East Pye Solar
The Applicant's Responses to Procedural Deadline
A and Additional Submissions

Planning Inspectorate Reference: EN0110014

Document Reference: EXAM/9.22

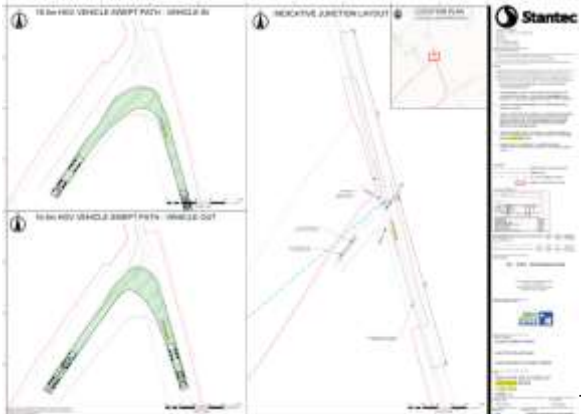
ID	Theme	Comments/Issues Raised	Applicant's Response
		There are also multiple instances of both roads having very low hanging tree canopies:

ID	Theme	Comments/Issues Raised	Applicant's Response
		 The Applicant does not appear to have assessed several important physical constraints affecting these roads. In particular:

ID	Theme	Comments/Issues Raised	Applicant's Response
		• Woodton Road and Shotesham Road are rural single-carriageway roads with limited opportunities for vehicles to pass; • Verges cannot safely be relied upon as informal passing areas due to the presence of hidden drainage ditches which are not always readily apparent to drivers unfamiliar with the area; • Certain sections are subject to weight restrictions; • There are locations where the available carriageway width appears insufficient for two cars and an HGV to manoeuvre safely without one vehicle reversing or leaving the carriageway; and • The roads serve residential properties, farms and local traffic and are not purpose-built freight routes. These characteristics affect the practical operation of the road network regardless of the number of vehicles predicted by the Applicant.

VEHICLE TRACKING
SHOTESHAM ROAD - WOOTON ROAD -
SPRINGWOOD LANE
16.5M HGV

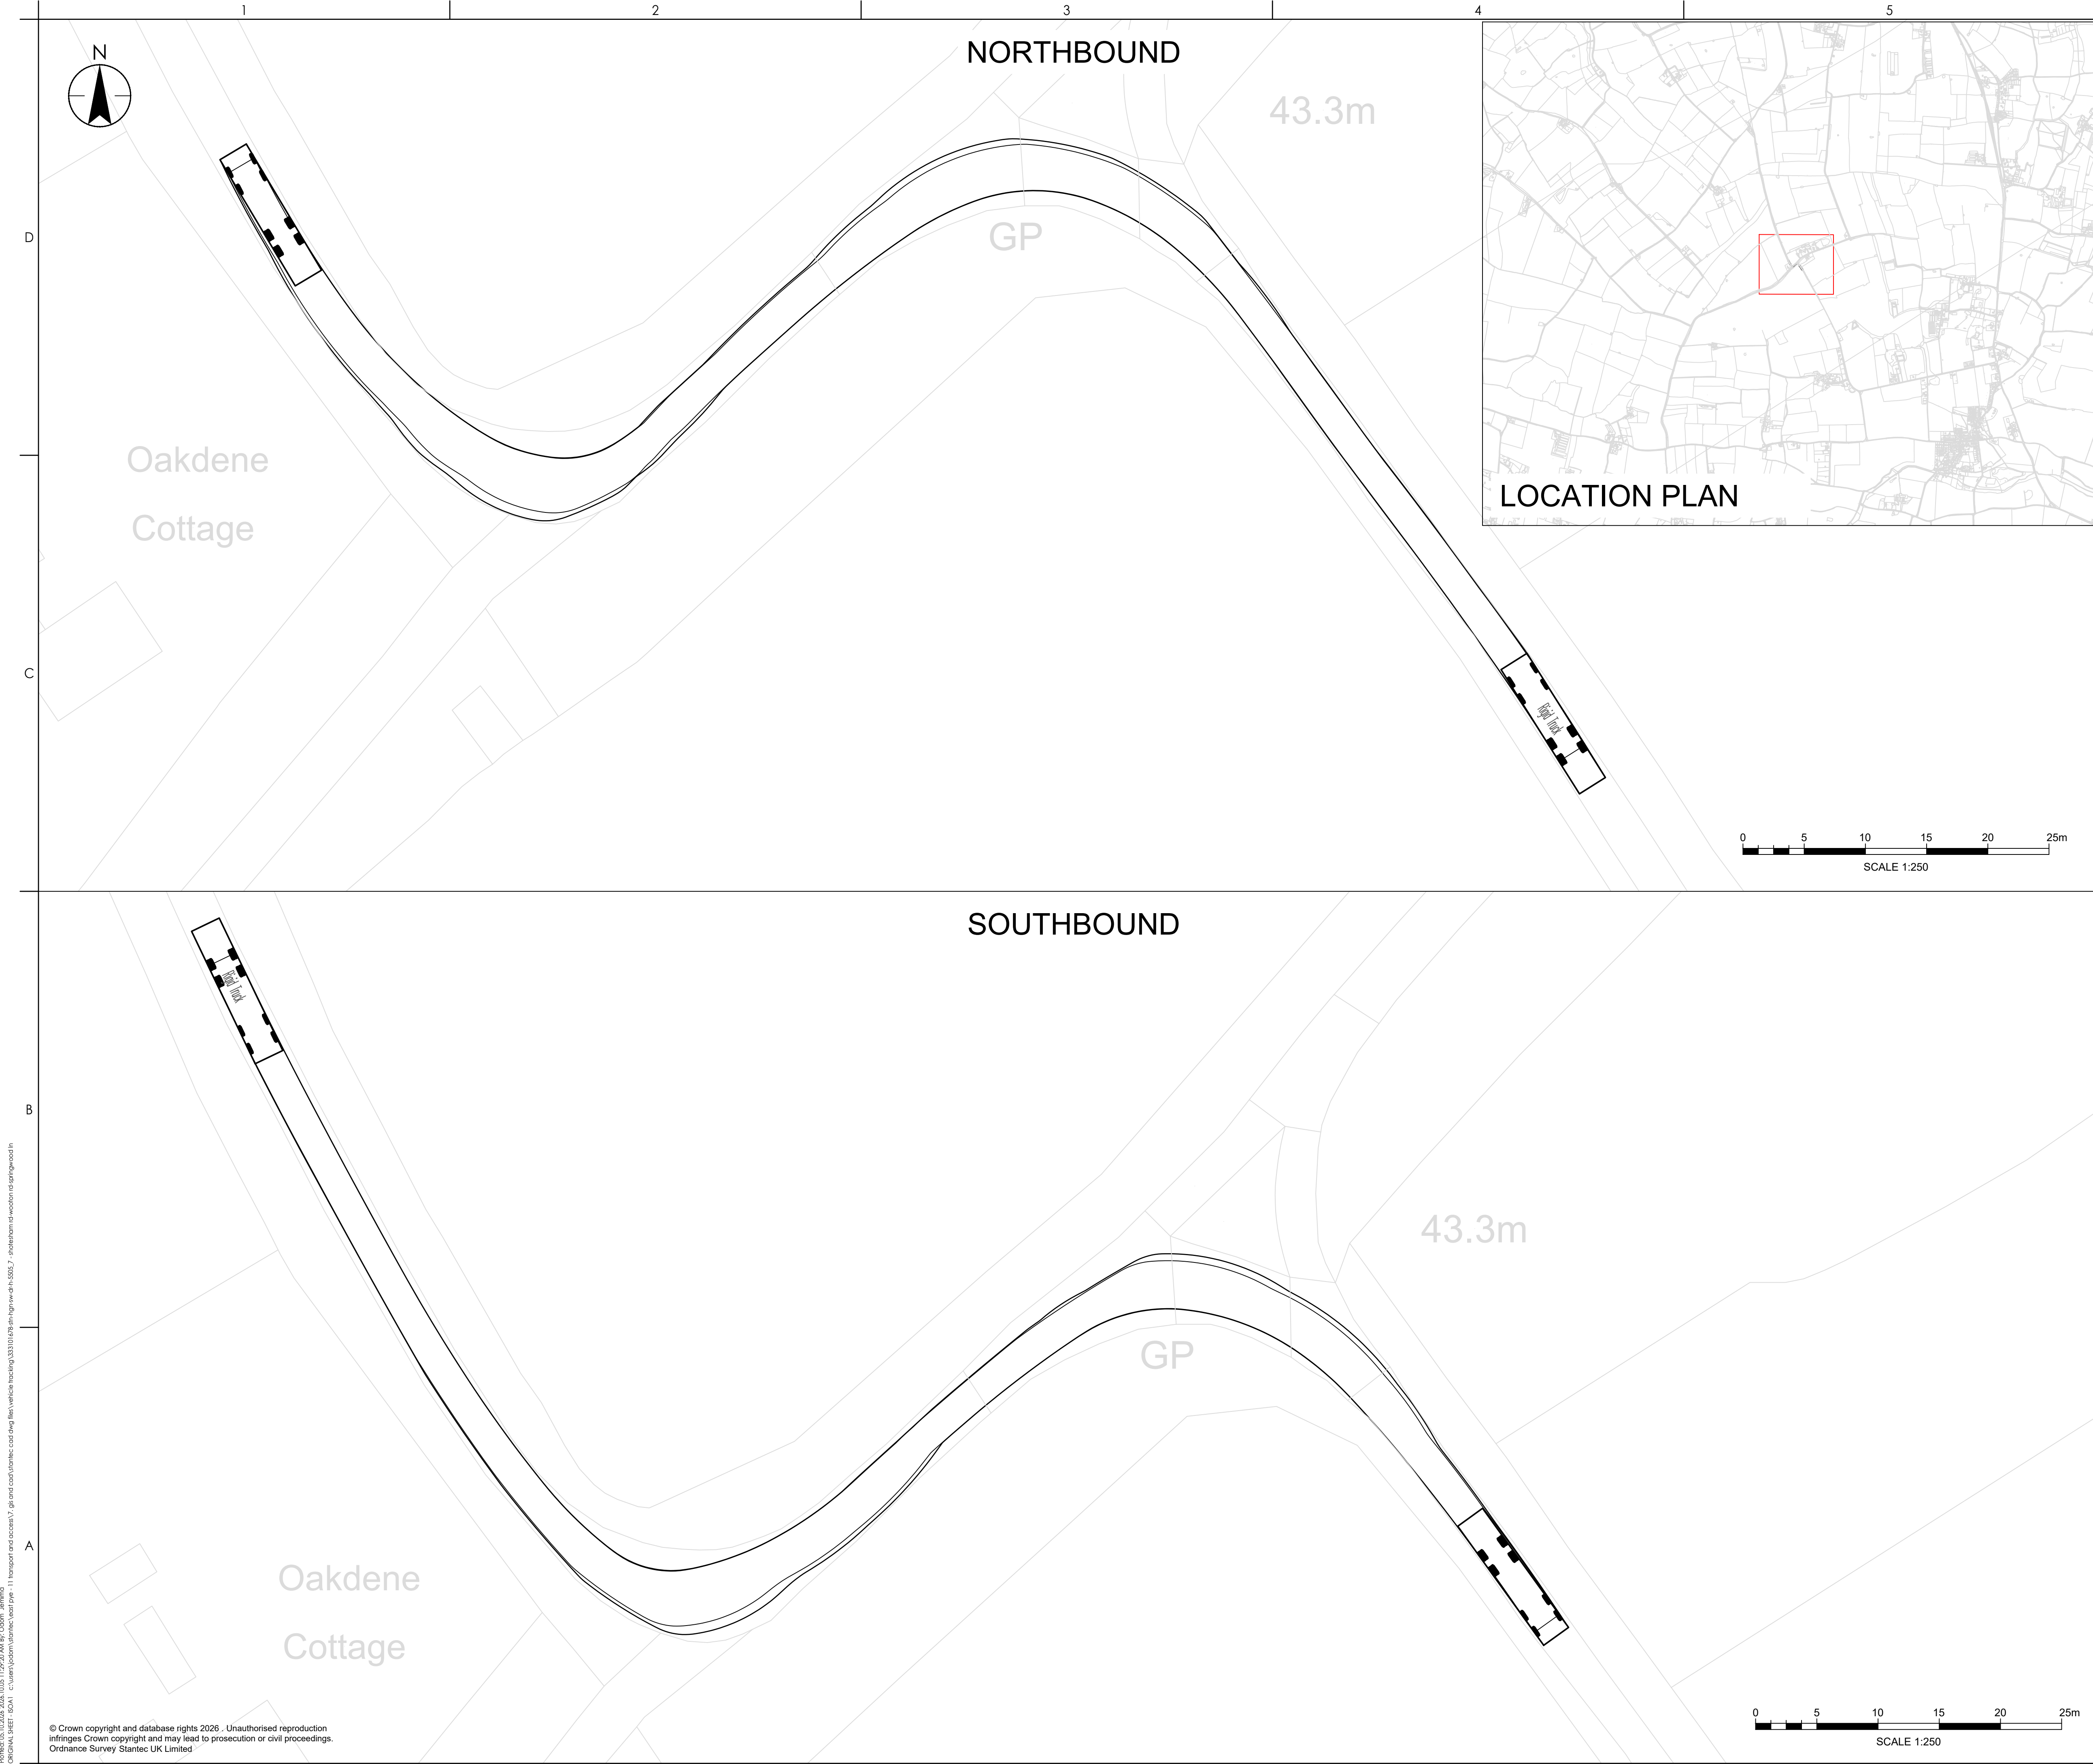
ID	Theme	Comments/Issues Raised	Applicant's Response
		 Sheet 7	
WPC-PDA-005	Transport and Access	The Applicant does not appear to have assessed the cumulative effect of multiple interventions proposed on the local highway network serving Springwood Lane. The proposals include street works, temporary alterations, temporary closures and a construction crossing on Shotesham Road, together with additional works, alterations and closures on Woodton Road. While each intervention has been identified	The Applicant notes the concerns raised regarding potential community severance effects associated with the combined impact of works on the local highway network. Community severance has been assessed within ES Volume 1, Chapter 4 – The Scheme [APP-040]. The Applicant does not agree that the Scheme would result in significant severance effects for Springwood Lane residents.
